# **Technical and Regulatory Comments**

**Regarding:**  
**Draft NPDES Permit Proposed by U.S. EPA Region 10;**  
**State of Alaska Certification under Section 401, Federal Clean Water Act;**  
**State of Alaska Approval Under Alaska Coastal Management Plan**

**Concerning:**  
**Wastewater Discharge of Tesoro Alaska Petroleum Company, Kenai, AK**

**June 19, 2000**

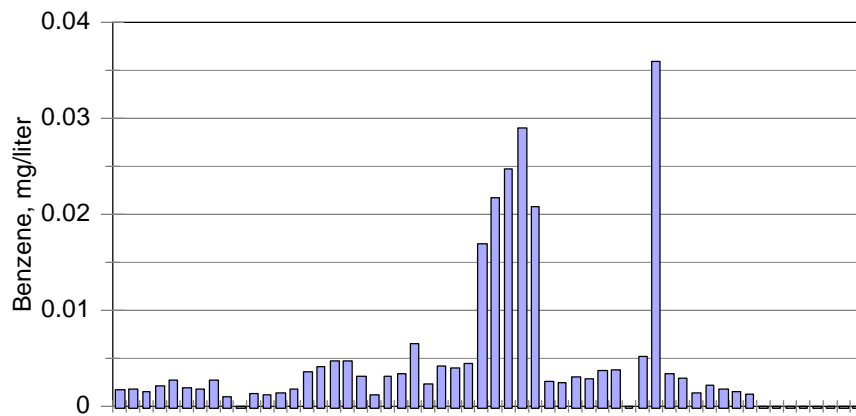
In 1997, Tesoro provided data on EPA Method 602 and 610 results on the PM Groundwater Remediation System effluent. The following chart shows this data from January, 1995 through July, 1997. Zeros in the chart are non-detects.

The chart below shows that Tesoro's PM effluent will be unable to continuously comply with the proposed benzene maximum daily permit limitation of 5.0 micrograms per liter (0.005 mg/liter) either at an internal monitoring point prior to introduction to the refinery's final secondary treatment system or as a discharge to Cook Inlet with no further treatment steps.

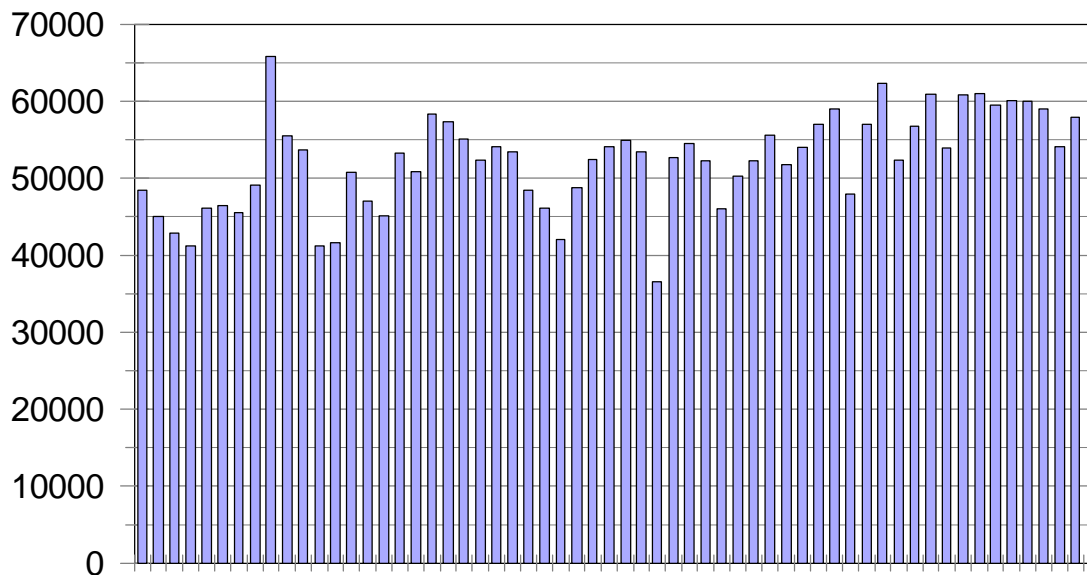
Production rate data and EPA’s analysis of it for the TAPC facility was obtained by this reviewer.<sup>21</sup> The data provided included total monthly production and the number of days each month there was no production. From this, EPA staff calculated a monthly average for each month on the daily production rate. A chart of this production data for January 1990 through December, 1998 is shown below.

If EPA Region 10 continues to use its “hybrid” procedure for developing technology-based effluent limitations for this plant (a procedure to which Commentors object, as per the prior section), EPA must downwardly revise its determination of the
